Tech Tips

TT 55-13-01 Date: July 12, 2013

2001-2006 Jetta Wagon, 2004-2008 Touareg (without Rear View Camera) – Rear Lid Does Not Open After Handle Replacement

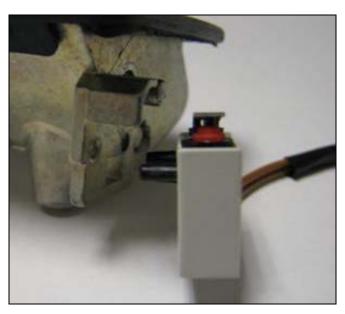
If the rear lid handle is replaced with part number 1J0 827 566L, the microswitch from the original handle must be transferred to the new handle. If original microswitch is not available, microswitch part number 1J5 962 104 B should be ordered and installed.

To remove micro switch, gently pry it away from handle.

To install micro switch, align mounting tabs with handle alignment holes.
